F6 Extension Stage 1  
Application number  
SSI 17\_8931  
Preferred Infrastructure  
Report  
SUBMISSION

This document contains the formal response to the Preferred Infrastructure Report (PIR) by the F6 Action.

This submission is an **OBJECTION** to the F6 Extension Stage 1 (the Project) i.e. the subject of the Preferred Infrastructure Report, and including the entire WestConnex proposal (WestConnex) of which the Project is a part. Any statements in this submission which refer to amelioration of predicted impacts should not be interpreted as endorsement or support for any aspect of the Project. It is F6 Action's position that the impacts of the Project are unacceptable and cannot be managed in such a manner that is acceptable. For the reasons set out in this response, we do not believe that the EIS meets the Secretary's Environmental Assessment Requirements (SEARS) and therefore no part of the EIS or this PIR should be approved.

Great Egret in breeding plumage, Northern Patmore Swamp (very close to President Ave) 9-11-2018

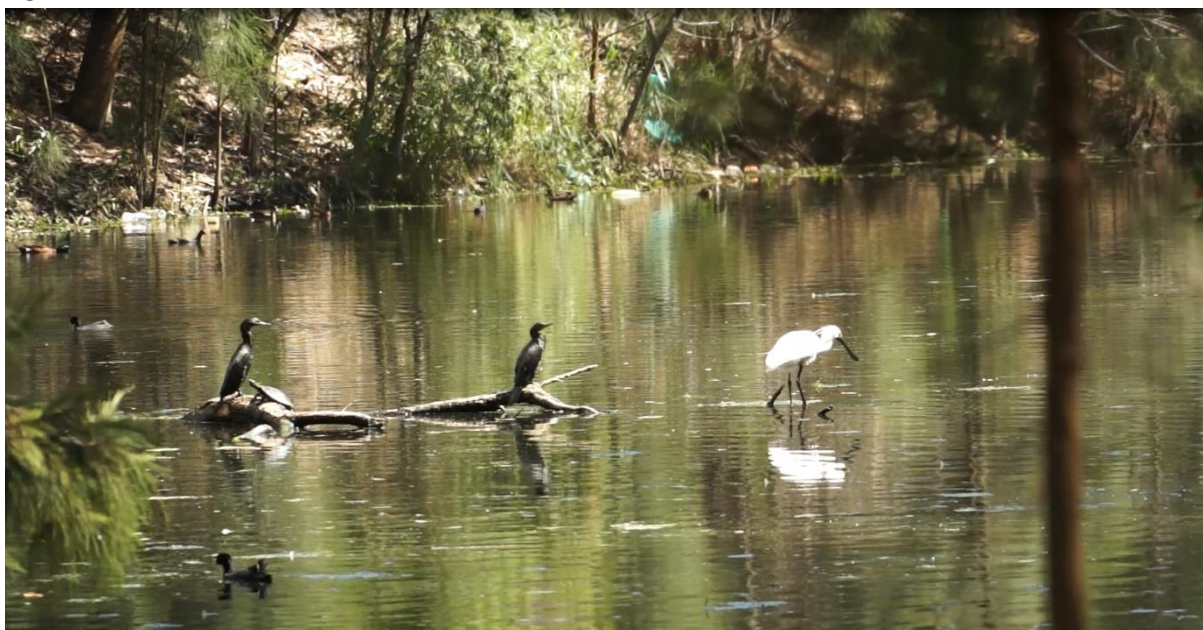
*While the species do occasionally occur close to the project, the species have not been observed to occur within the construction boundary. (Pg. 12-31)*

Just because RMS has not observed them does not mean that migratory species do not exist here. Here is an example of a recent photo of a migratory species taken by locals, within your construction boundary. We have several other examples taken over the years.
